PLACER COUNTY PLANNING DEPARTMENT

PLANNING APPEALS

- Project name Homewood Mountain Resort Ski Area Master Plan
- Appellant(s) Friends of the West Shore, et al. (Attachment 1) 530-525-5452

Re: Homewood Mountain Resort Ski Area Master Plan (California State
Clearinghouse #2008092008, Placer County Project Number PEIR T20080052
and TRPA Project Number STD20061130)

Figure 15-15. Off-Site EIP Project Design Schematic

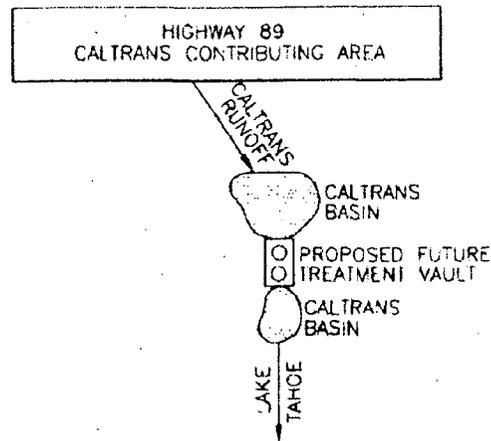
To increase the HMR-CEP effectiveness, consideration should be given in a revised DEIR to routing stormwater to an infiltration gallery after treatment by the Contechs system, in a fashion similar to the treatment train that is proposed for stormwater treatment for the project. Discharge to a basin, especially during high-flow conditions will not be as effective in reducing TSS.

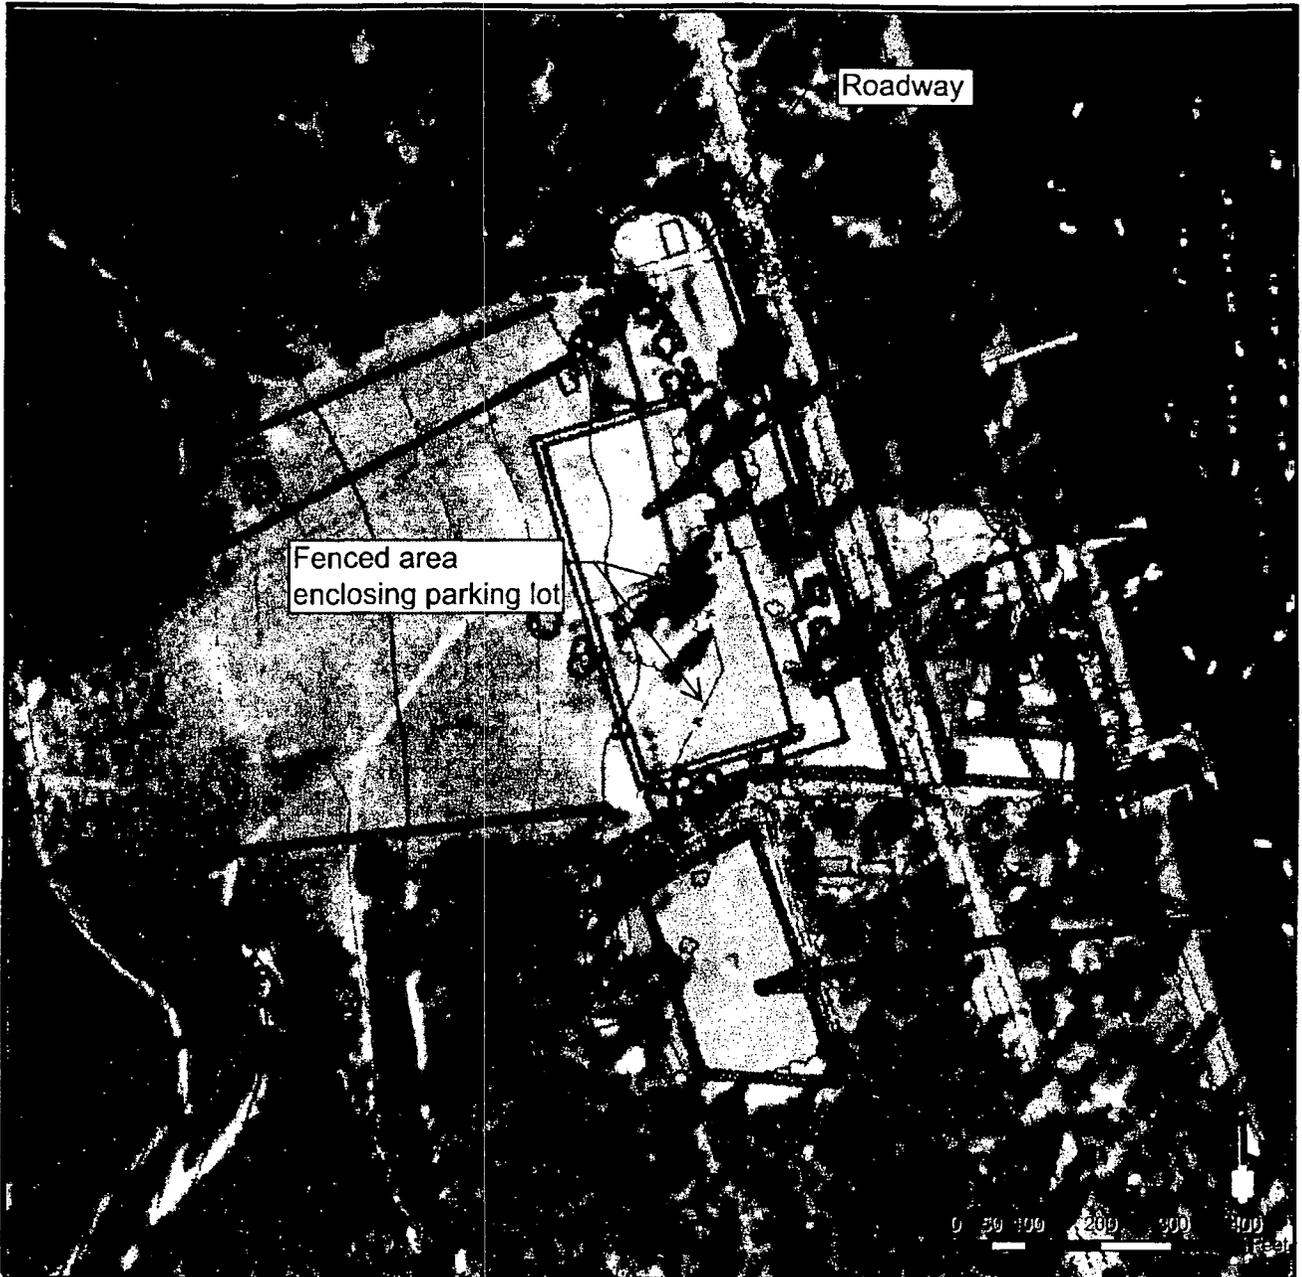
Additionally, we have conducted an analysis of the North Base parking lot and have determined that the majority of the parking lot was not in existence as of February 10, 1972. Figure 2 shows an overlay of a map prepared on the basis of conditions that existed as of November 1971 (Attachment 2), arguably the same conditions that would have existed on February 10, 1972 given that the winter season would have prevented any further development.

Figure 2 depicts two features that indicate the parking lot was not in existence in February 1972.

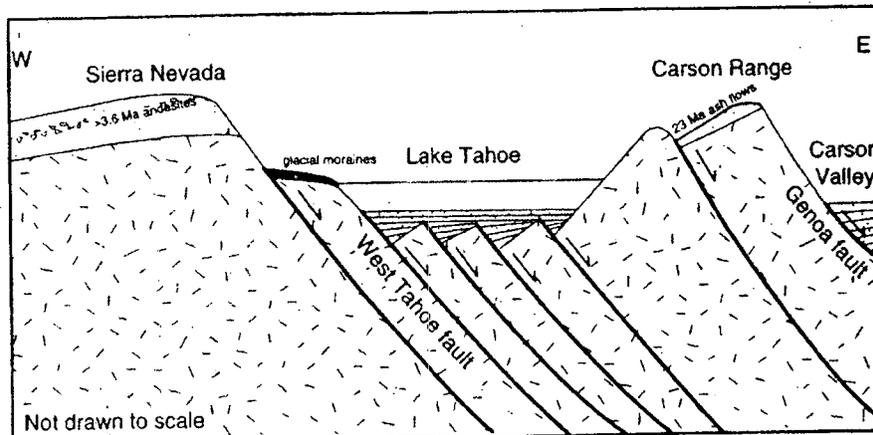
Lake Tahoe and the Tahoe Basin have been created by episodic, differential displacements across a suite of generally north-south trending faults (Figure 1). Although the faults were always suspected of being geologically young, it is really only in the past decade that research has begun to both confirm, and generate quantitative results on just how active they are. In essence, the paradigm of seismic hazards and vulnerability of the Tahoe Basin is in flux, and that hazard is definitely increasing. It is therefore unfortunate that the Homewood Resort's EIR relies on generally older references to the seismic hazards, sources which have mostly been superseded by more recent, and more technically advanced, studies. That the two geotechnical engineering reports do not provide this information either probably made the EIR preparer's task more difficult.

In my opinion, Unnamed Fault 1 is the west bounding fault system for the Tahoe Basin graben (Figure 1 and 4). It has a total length of at least 15 miles, it controls the location of Quail Lake (Figure 3), it ties directly into the known active fault through the lake (West Tahoe fault), it is identified as potentially active, and it has major hazard implications for the project that have never been quantitatively addressed.

Figure 2: Annotated geologic map of the western side of Lake Tahoe, labeled to show the primary fault systems, and a potential northward extension of the Unnamed Fault 1. Modified from Saucedo, 2005, and available at <http://www.quake.ca.gov/gmaps/RGM/tahoe/tahoe.html>

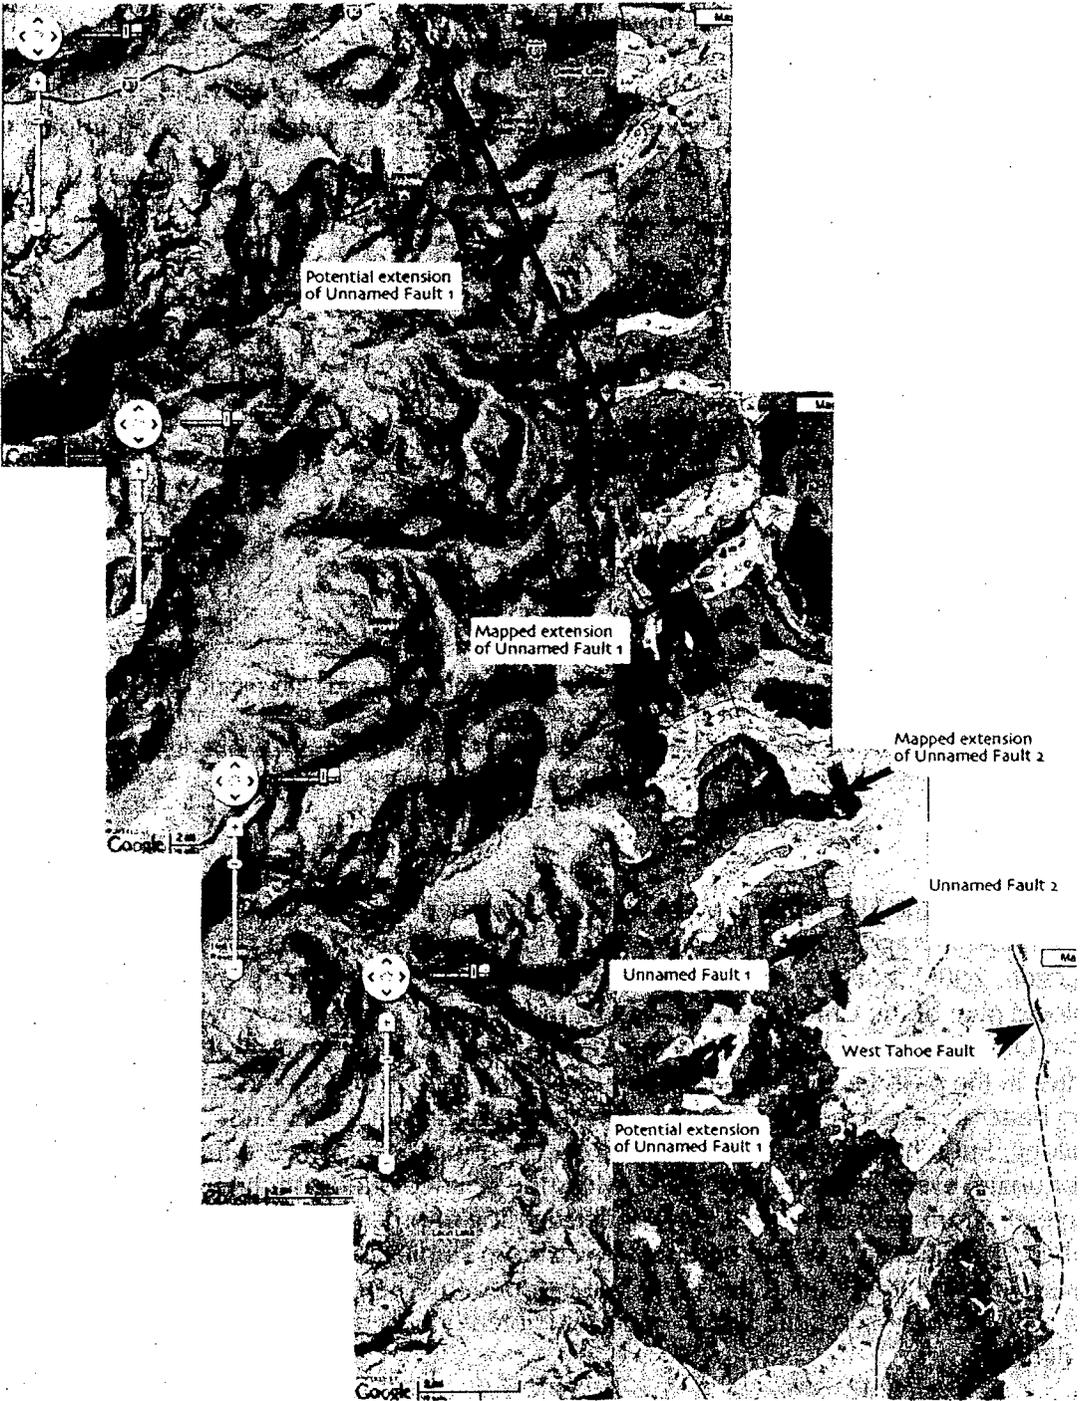
On Page 14-8, the EIR makes a point that the Unnamed Fault #1 (Figures 2 & 3) is shown as a Quaternary-age fault on the more recent Geologic Map of the Lake Tahoe Basin (Saucedo, 2005), but they make more of a point that the fault is not shown on the older geologic map of the Chico Quad (Saucedo and Wagner, 1992). The obvious interpretation is that Unnamed Fault 1 was discovered during the significant focus on Lake Tahoe seismic studies in the past decade. Indeed, the newer map is authored by the same geologist. Who better to revise their own work? This does not make it a new fault, it has been there all along, but it had not been mapped during the prior work. This is a frequent (though unfortunate) event in geology, because while the science builds on the past work, it progresses from new exposures, new understanding of processes, and new expertise being applied. In this case, I would note that it was from studies focused on the seismic hazards of Lake Tahoe that identified this fault, that mapped this fault, and that consider it to be at least a Quaternary-age fault, which makes it "potentially active" under California A-P regulations.

The EIR also states that the fault is short and discontinuous, making the hazard low for it to be big enough to be hazardous. This is neither accurate nor true. The Unnamed Fault 1 has been mapped at least another 5.5 miles north of the project site (to the limits of the Tahoe Basin mapping), and the geomorphology of the fault can be interpreted for at least 4.5 more miles past the map limits (Figure 2). Furthermore, the southern termination of the Unnamed Fault 1 can (and should) be interpreted as stepping to the west onto another unnamed fault system that continues an additional 5 miles southeast before joining with the West Tahoe Fault in Emerald Bay (Figure 2).

Unnamed Fault 2 (Figures 2 and 3) is in a similar category. The fault is considered to be Quaternary in age, making it potentially active according to the A-P Act and as stated in the EIR. It appears to form the margin for the lake level of Lake Tahoe (Figure 2), indicating that it may be an active structural feature controlling the shoreline location (Figure 3). The EIR even states that the fault is located along a break in slope. This geomorphic feature is presumably formed of the surficial (and therefore young) deposits that underlie this eastern part of the project (Figure 3). Is this "break in slope" a fault scarp, which, when combined with the young deposits, would certainly make this a Holocene-age feature? No matter what it is, it is inconceivable that the presence of a potentially active fault, lying parallel and proximal to a known active fault, and coincident with a scarp-like geomorphic feature, would not trigger a competent and professional geologic investigation.

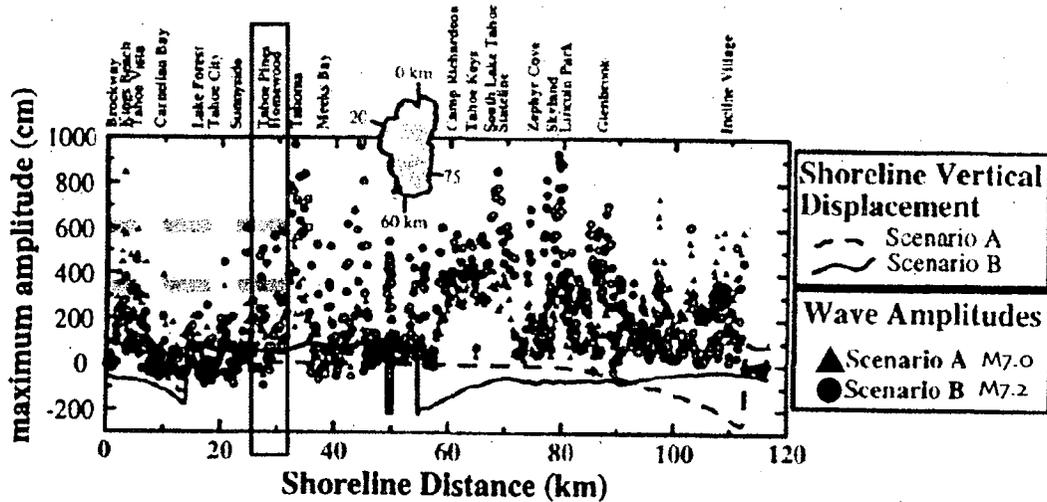
Ichinose et al. (2000) modeled the lake basin deformation from M_w 7.0-7.2 earthquakes on the Tahoe basin faults and estimated that tsunami wave amplitudes could be between 3 and 10 m, depending on the shoreline geometry around the lake. At the Homewood project site, they model a 3.5 to 6.0 meter wave height runup (Figure 7). While still

somewhat controversial, Gardner et al (2000) proposed that a large earthquake on the Tahoe basin faults triggered the McKinney Bay mega-slide [Schweickert et al. (2004) estimated a Holocene age for the event], and modeled that the landslide could have produced a tsunami wave more than 100 m in height.

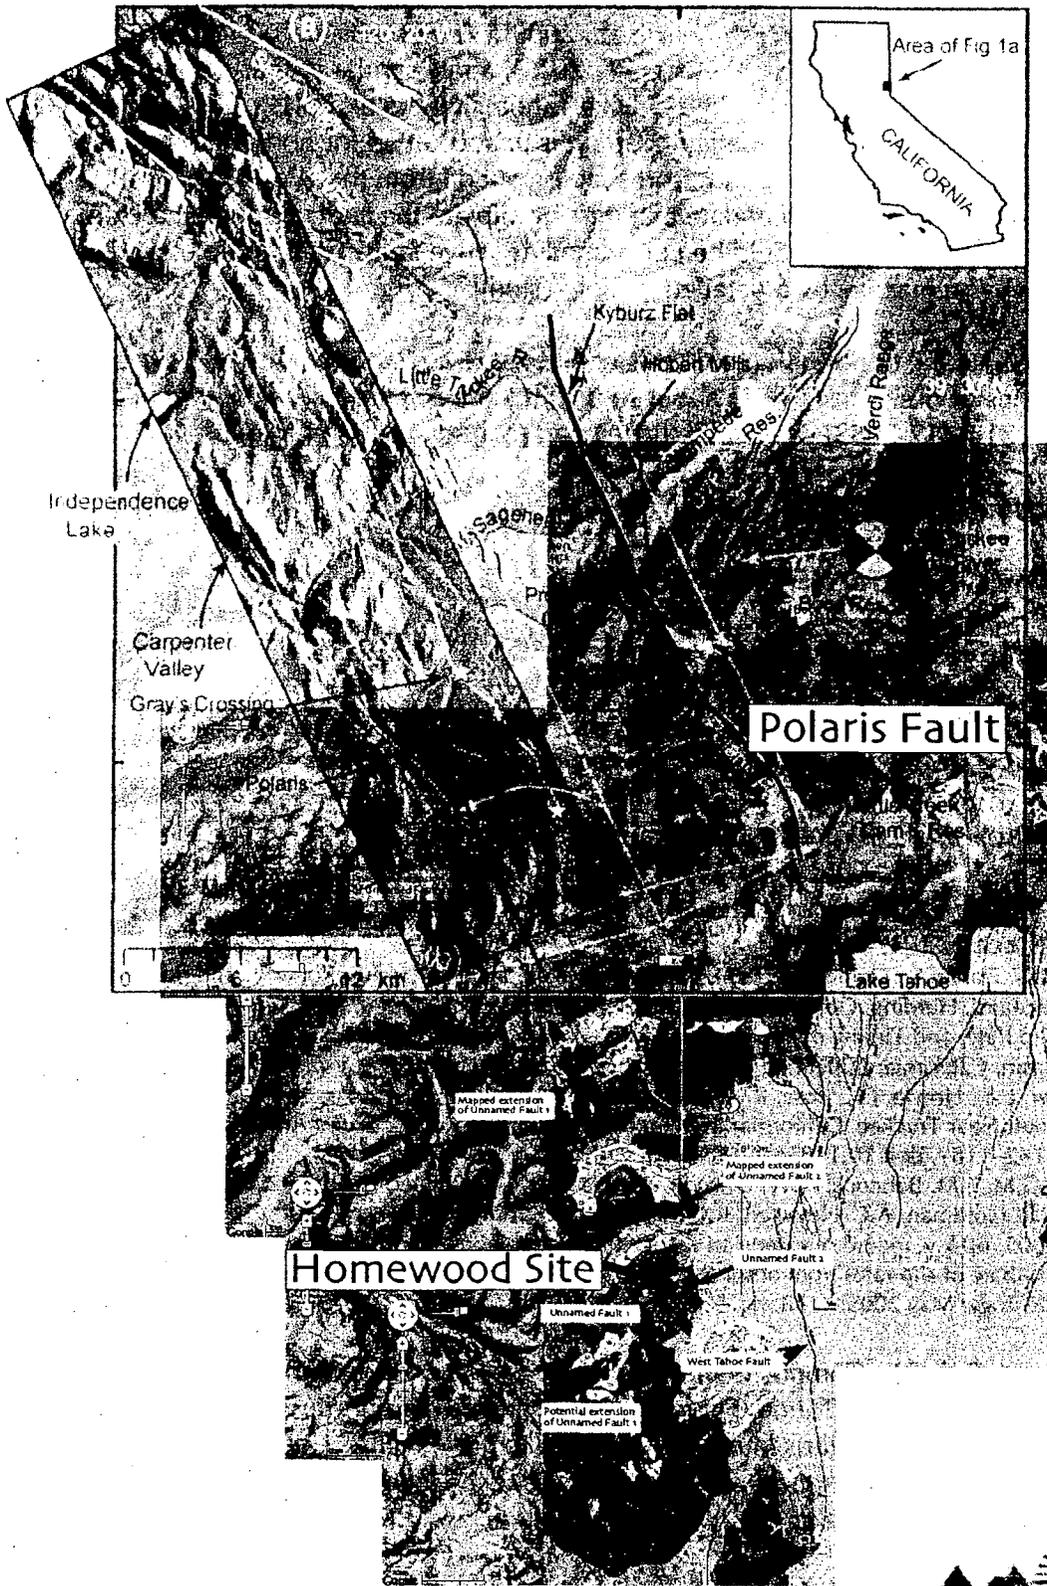
The Newly Discovered "Polaris Fault" and its Relationship to the Faults Through the Homewood Resort
